SECTION 00 91 12

ADDENDUM NUMBER 3

- 1.01 DATE: MAY 23, 2018
- 1.02 PROJECT: AUSTIN HIGH SCHOOL CAREER TECH CENTER
- 1.03 PROJECT NUMBER: B. C. NO. 2018112
- 1.04 OWNER: DECATUR CITY SCHOOLS
- 1.05 ARCHITECT: NOLA | VAN PEURSEM ARCHITECTS, PC

12
A-2.1

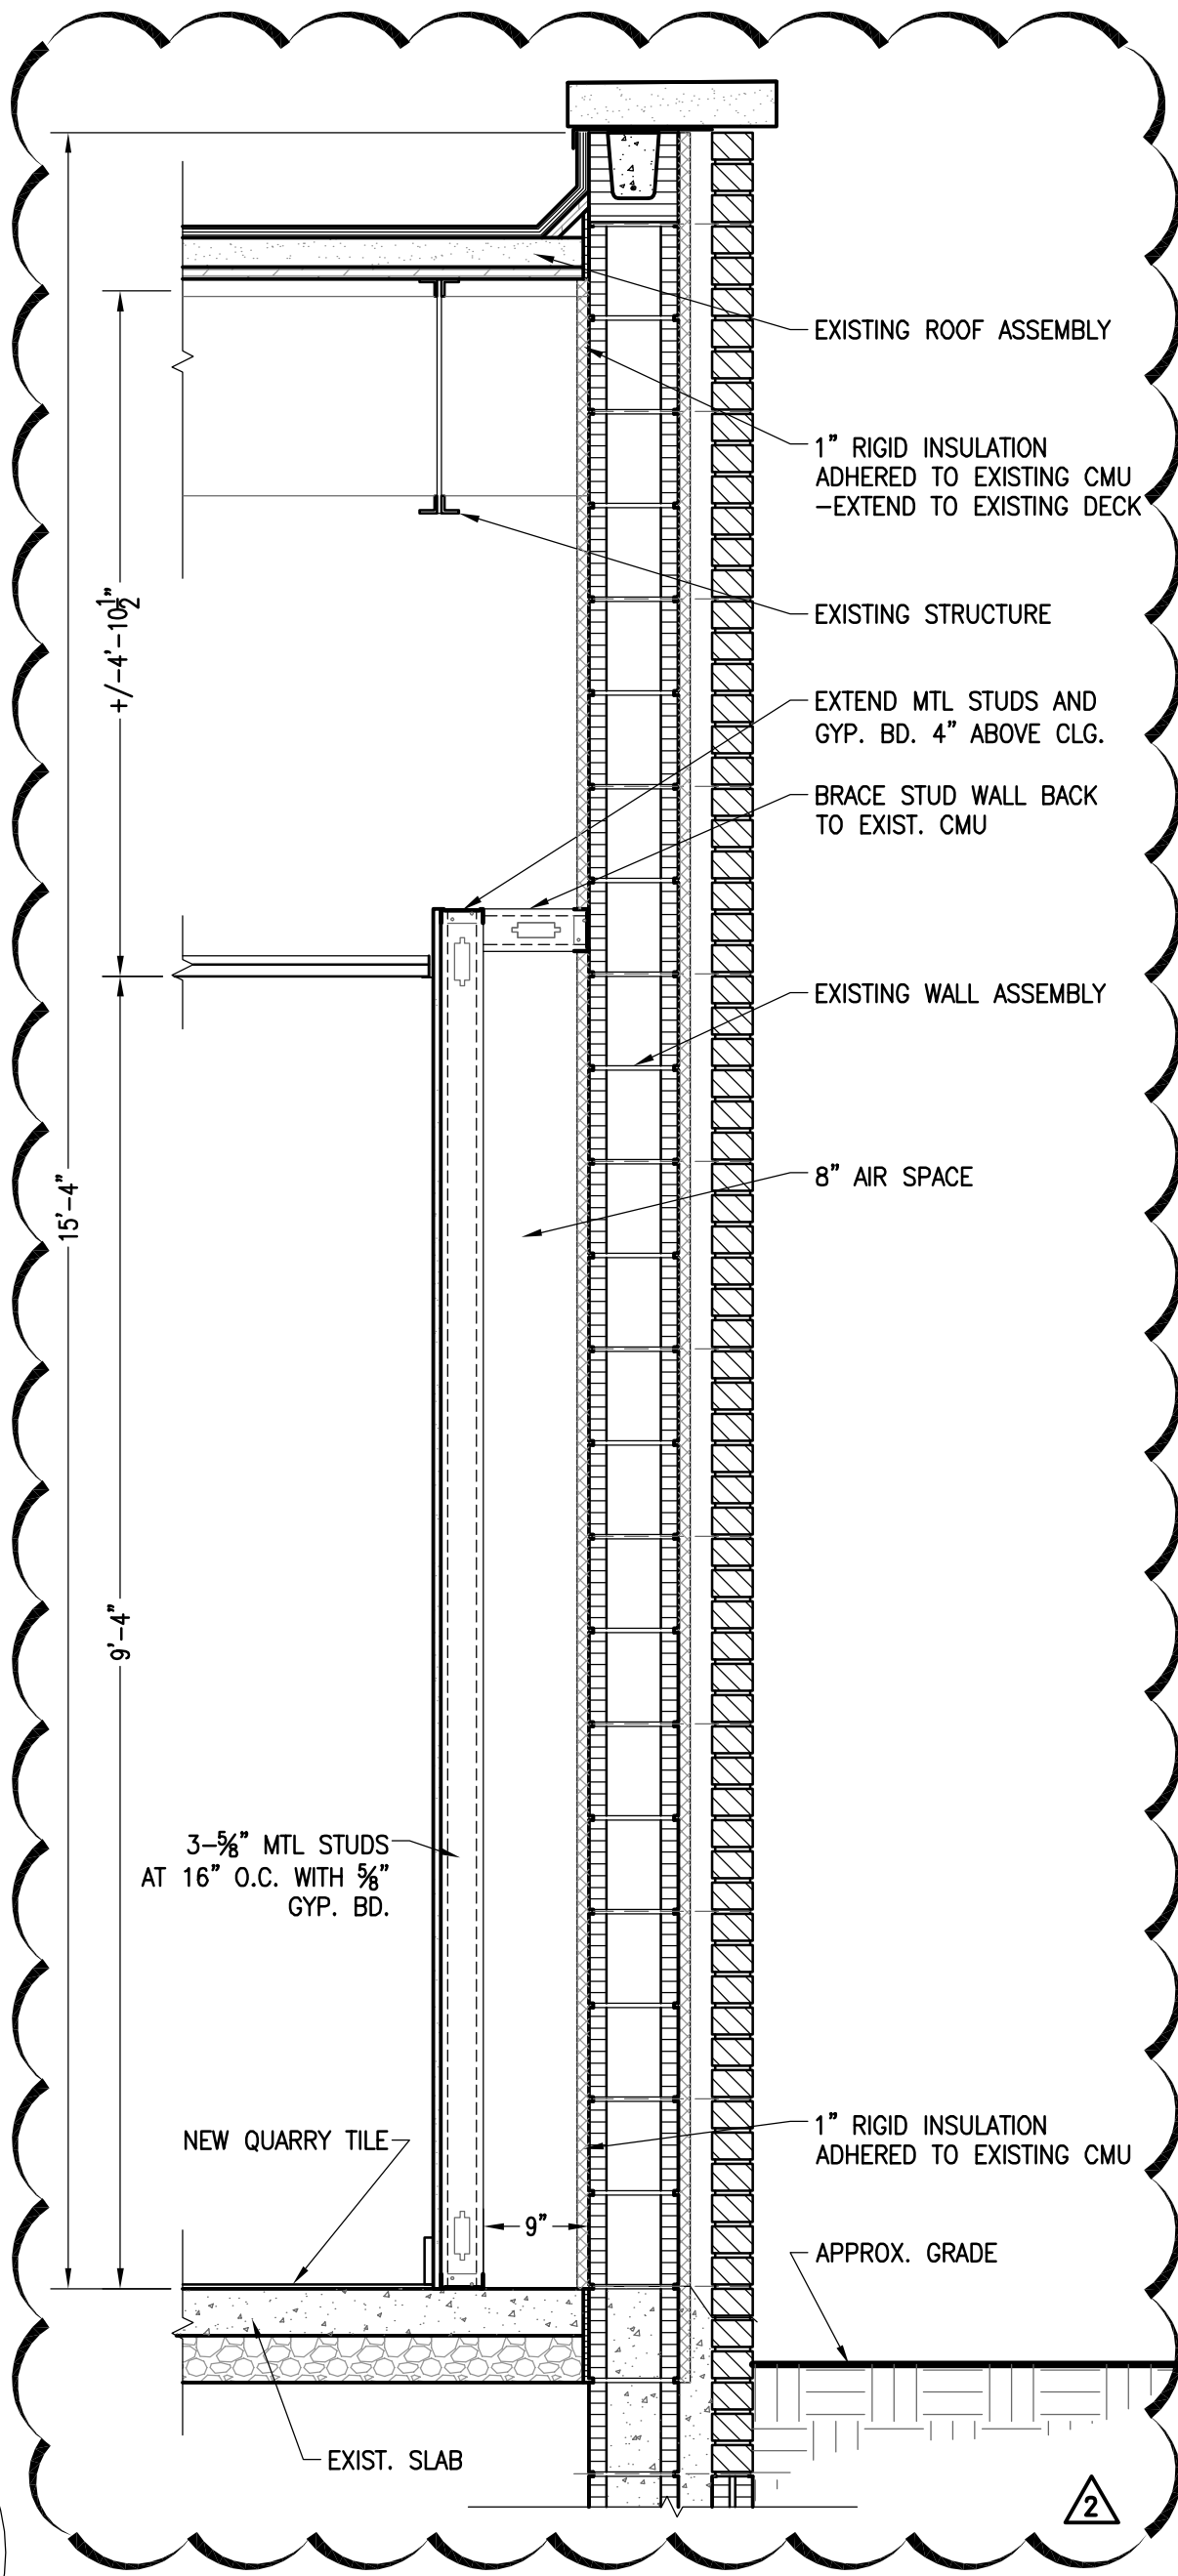
- A. Wall Type Legend: Add reference to detail 12/A-2.1 on wall type 3.

- A. Add Wall Section 12/A-2.1 per attachment AD3-A2.1-01.
- B. Revise note 9 on “Room Finish Notes” to read, “All new and existing hollow metal doors and frames shall be painted, interior and exterior. No work is needed on existing wood doors.”
- C. Add note “Continuous #5 bar in bottom of bond beam” to wall section 10/A-2.1.
